3.0L Lower Mount Clamp and Cover

Models Covered	Serial Number
Mercury/Mariner All 3.0L engines	1B775626 and above

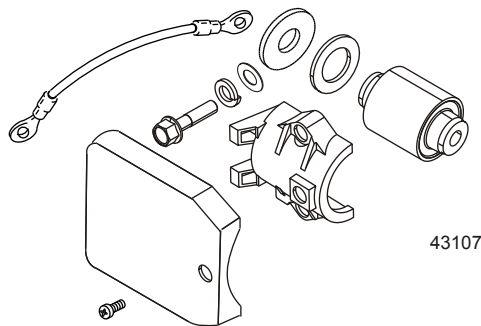
The 3.0L lower mount clamp has been changed to include three fasteners to hold the mount cover secure. The current single screw design is now NLA and is superseded by kit P/N 879150A90.

When servicing the lower mount cover or clamp with the single screw design, please order P/N 879150A90 cover kit. The kit will include the cover, the mount clamp, and three screws to secure the cover to the clamp.

- The new kit will backfit to all 3.0L models.
- The new three screw design components will be available as individual parts.
- Single screw and three screw components will not work together and are unique unto themselves. The three screw and single screw designs cannot be comingled.
